Our Ref: 16065

**RE: MARRICKVILLE METRO S75W PROPOSED MODIFICATIONS  
RESPONSE TO SUBMISSIONS**

As requested, The Transport Planning Partnership (TPPP) has prepared this letter in response to submissions made by the consent authorities/agencies in relation to a Section 75W application for the above proposed development submitted to the Department of Planning and Environment.

Figure 2: LGA/Sydney/NSW Rear End Crash Proportions (2012-2016)

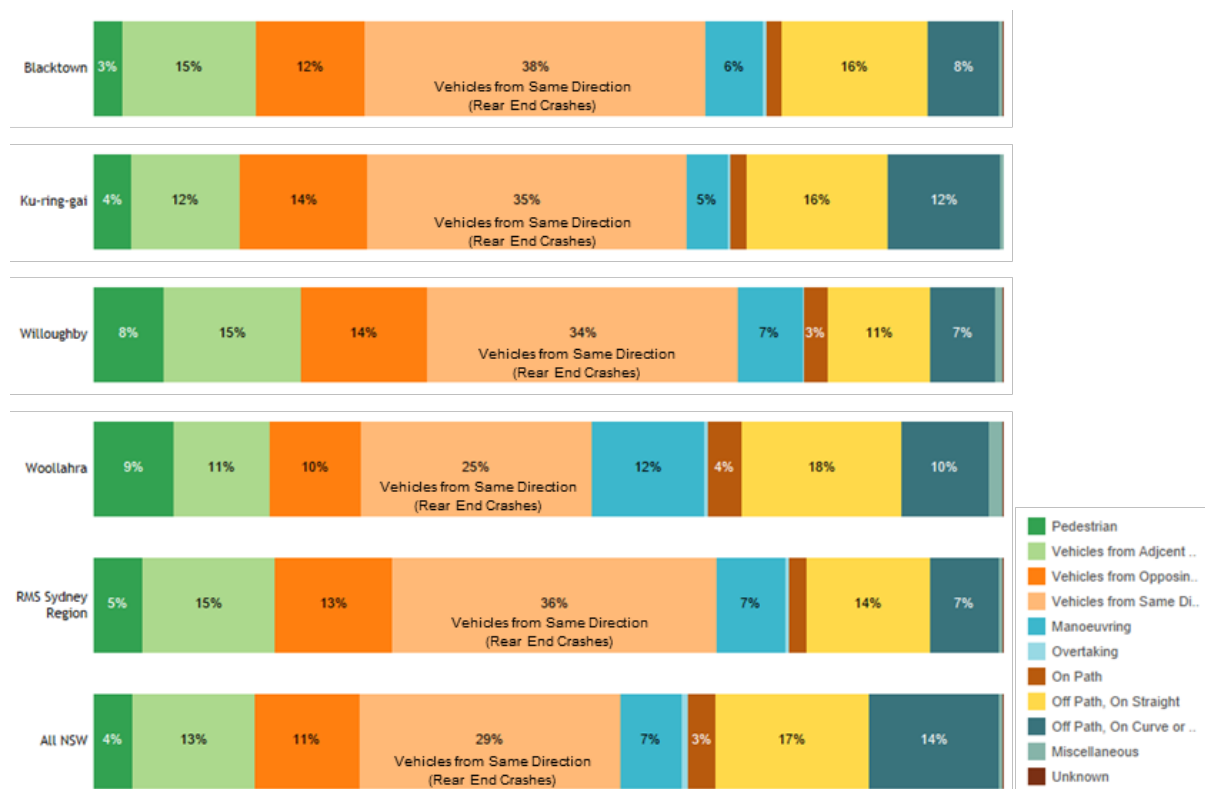
*The proposed right-turn access and bay along Edinburgh Road has the potential to increase the risk of rear-end vehicle collisions due to its proximity to the traffic control signals at Edinburgh Road and Smidmore Road. There is the potential that drivers seeking to turn right at the traffic signals may not expect the sudden stopping of a leading vehicle waiting to turn right into the Edinburgh Road access.*

Figure 2 shows that rear end crashes has the largest proportion of crashes across Sydney and wider NSW regardless of the road arrangements and configurations. The proportion of rear end crashes can be as higher as 38 per cent in Blacktown LGA and 36 per cent across Sydney region.

From the above analysis, it can be seen that the number and proportions of rear end crashes at existing combined right turn lane are not atypical of Sydney and NSW crash characteristics. As such, the proposed combined right turn arrangement is not expected to result in increase in rear end crashes.

Figure 3: Edinburgh Road Signage

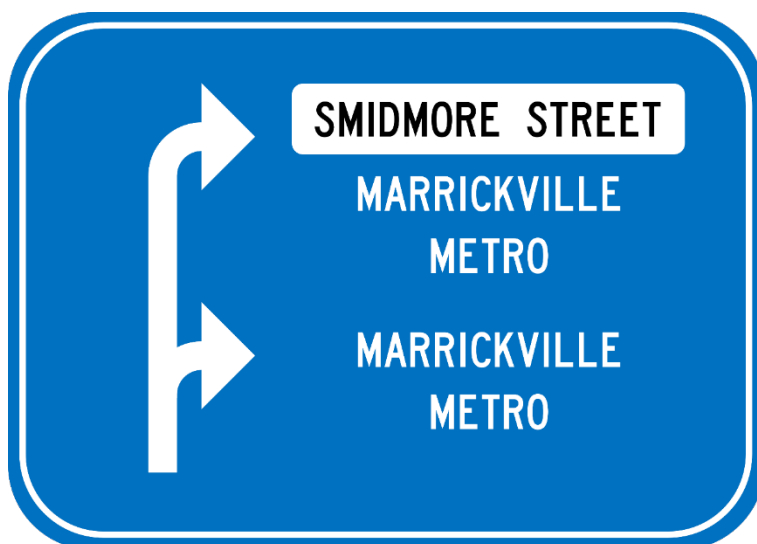
*As a minimum, it is advised that separate right-turn bays should be provided for each movement subject to satisfactory analysis demonstrating that the resultant right-turn bays would be adequate for estimated vehicle queues. This would also require the restriction of right-out egress movements to Edinburgh Road (as proposed).*

In addition, there would be signage provided along Edinburgh Road indicating the location of the turn facilities. An example of such a sign is shown in Figure 3. This would assist with reducing any potential of rear end crashes.

Figure 4: Comparison of Approved and Proposed Access Arrangements

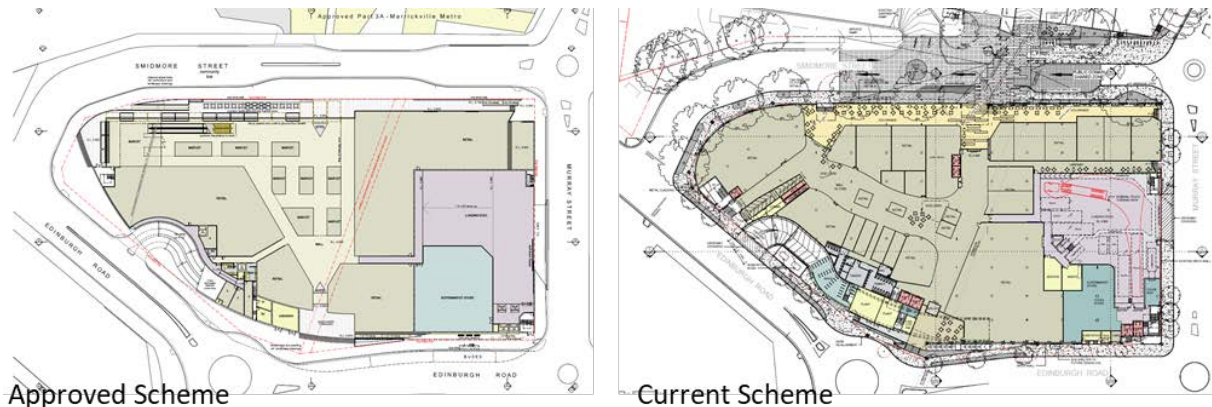
*Stage 1B (southern block) only consists of one entry/exit to proposed new carpark. This access is from Edinburgh Road. It would be preferable for this entry/exit gate to be further east along Edinburgh Road to avoid any conflicts with the operation of the signalised intersection of Smidmore Street / Edinburgh Road.*

*Consideration of an additional entry/exit to this new carpark is warranted (on safety grounds) given the number of car parking spaces it is to contain. If not feasible, an alternate solution would be to provide vehicular access from one carpark to the other carpark (Stage 1B link to Stage 2). For emergency purposes it is appropriate that vehicular access from at least two entry/exit points be provided*

In response, TTPP notes that the proposed access arrangement in the current application is consistent with the approved development in terms of location and number of access points as shown in Figure 4.

The proposed access location was approved at approximately halfway on Edinburgh Road between Smidmore Street and Sydney Steel Road. The current scheme does not propose to alter this approved location. It is also noted that the proposed access location is generally in the same location as that of the existing industrial use that is being displaced by the proposed development.

The approved development includes one access point located off Edinburgh Road. This will continue to be the case in the current scheme.

Figure 5: Parking Occupancy Survey Locations

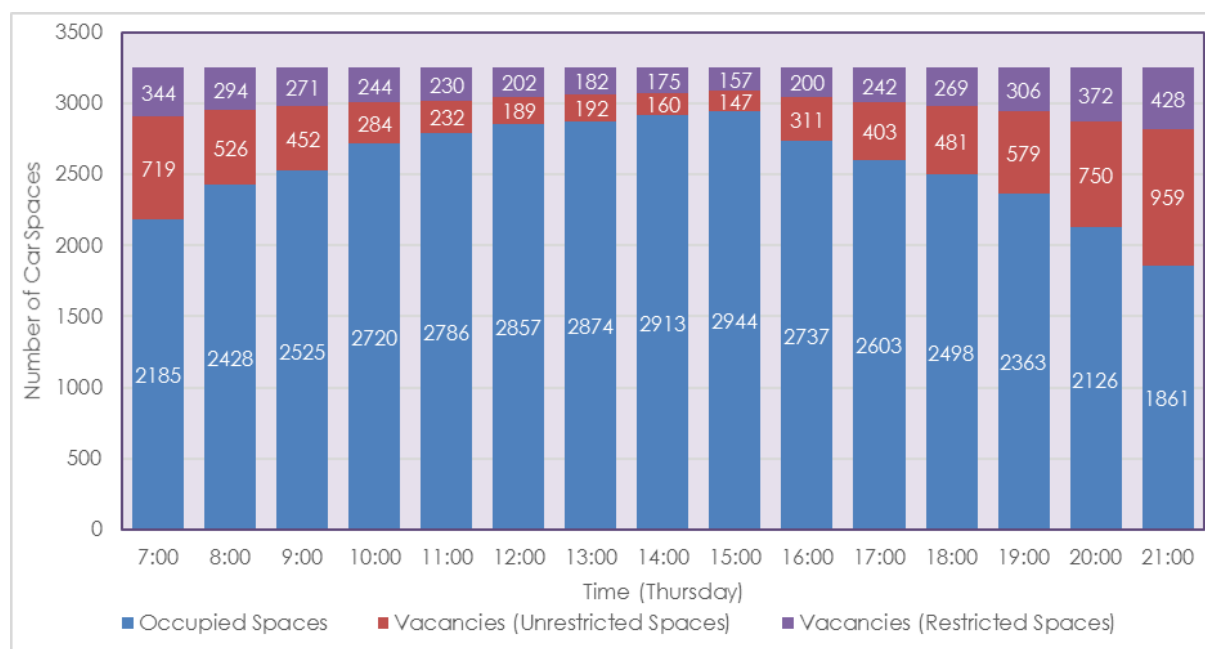
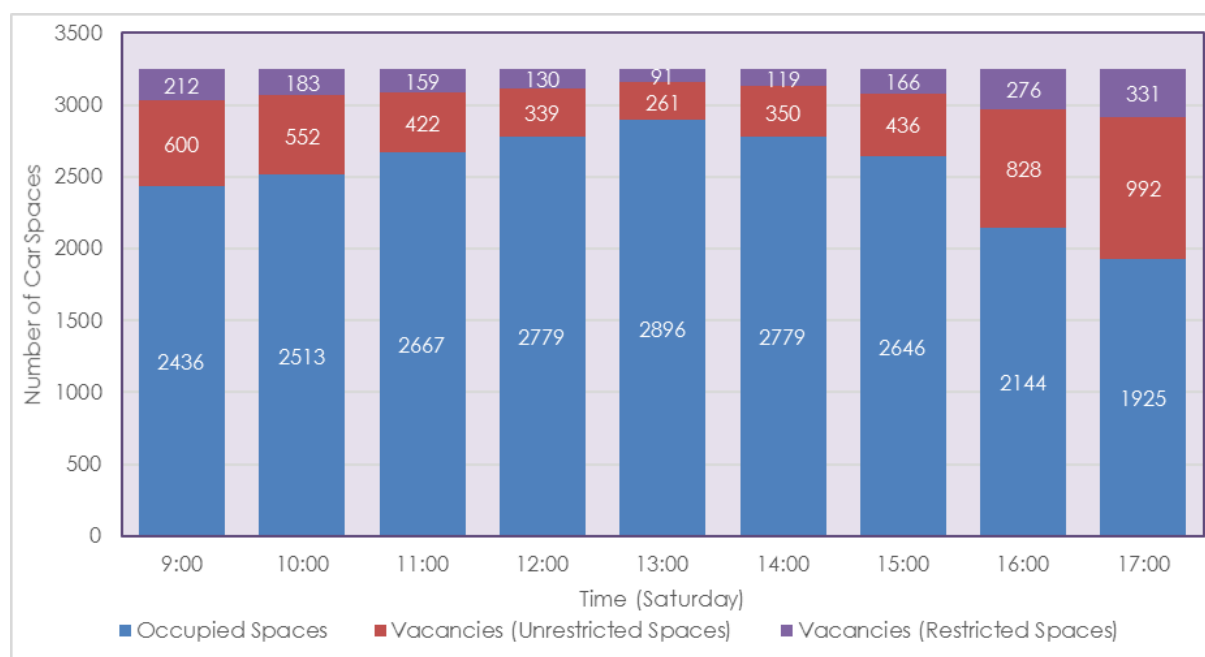
*Additional detail on the parking provisions for the proposal should be highly considered with reference to Council's current DCP. It is noted that the amended proposal includes the introduction of paid parking to the carparks with a timed period of free parking. The proposal states that the employees to businesses within the shopping centre will not be exempt and therefore this will have an impact on the on-street parking demand in nearby streets. It is considered that adequate staff parking should be provided on-site*

*and/or staff be exempt from the paid parking restrictions. Demonstration of how this will be managed by centre management and staff will need to be provided.*

Separately, parking occupancy of on-street parking spaces within 800m distance of the Marrickville Metro Shopping Centre was carried out on Thursday 22 February 2018 and Saturday 24 February 2018. The areas where the parking occupancy surveys were conducted are shown in Figure 5.

From the above parking occupancy survey results, there is a spare parking capacity of approximately 304 parking spaces comprising 157 restricted parking spaces (4P parking or less) and 147 unrestricted parking spaces (greater than 4P).

**Figure 9: Traffic Modelled Area**

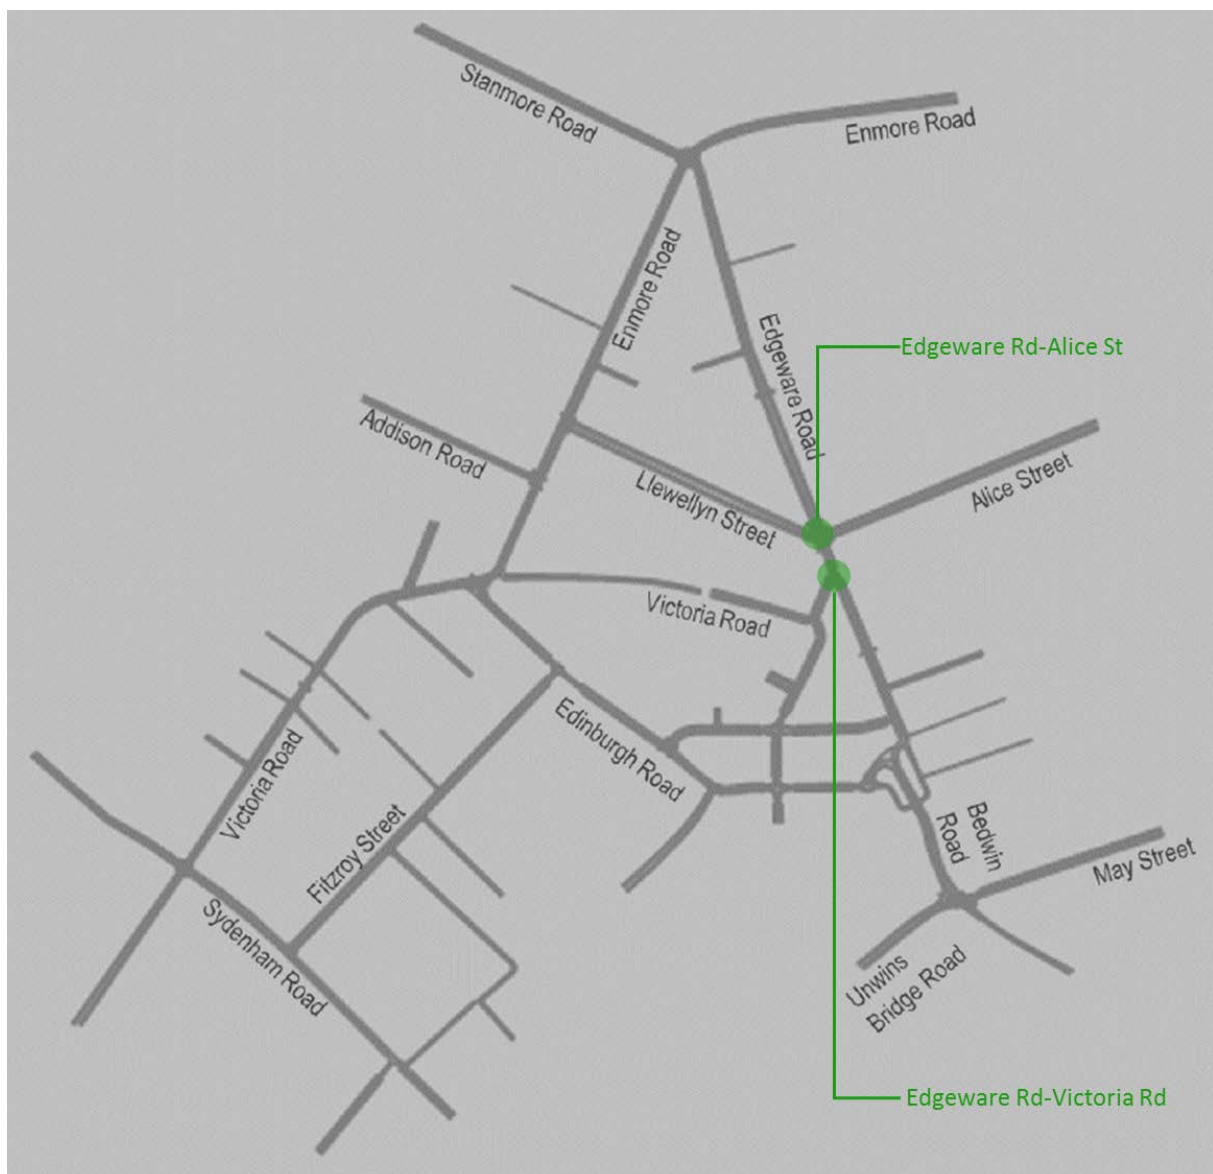
*The crossing at Victoria Rd on Edgeware Rd crosses 2 lanes of traffic in each direction. This is a significant danger to pedestrians who are reliant sometimes on making visual contact with 4 cars at the one time in order to cross the road. The proposals do not appear to offer an alternative to this and the proposal to remove Edgeware Rd parking on the east side at busy periods will likely increase the vehicle demands to make the turn into Victoria Rd quickly."*

TTPP confirms that the intersection modelling has not been conducted in isolation. Intersection modelling to assess the traffic effects of the proposed development has been undertaken through the development of a micro-simulation traffic model of the local road network on the traffic modelling platform known as Vissim. The Vissim model takes into account the downstream and upstream traffic effects at each intersection.

The traffic model covers the road network surrounding the proposed development site and it includes the two Edgware Road intersections at Alice Street/Llewellyn Street and Edgware Road named in the above submission. The coverage of the traffic model is discussed in the traffic assessment report. The modelled area reproduced from the report is reiterated here as Figure 9. Figure 9 also shows the locations of the two intersections named in the submission.

It is noted that prior to the development of the microsimulation traffic model, TTPP consulted Roads and Maritime Services on the traffic modelling methodology and assumptions to be adopted for the development of the traffic model. Roads and Maritime Services approved the modelling methodology including the development of the Vissim model and the proposed modelled road network shown in Figure 9.
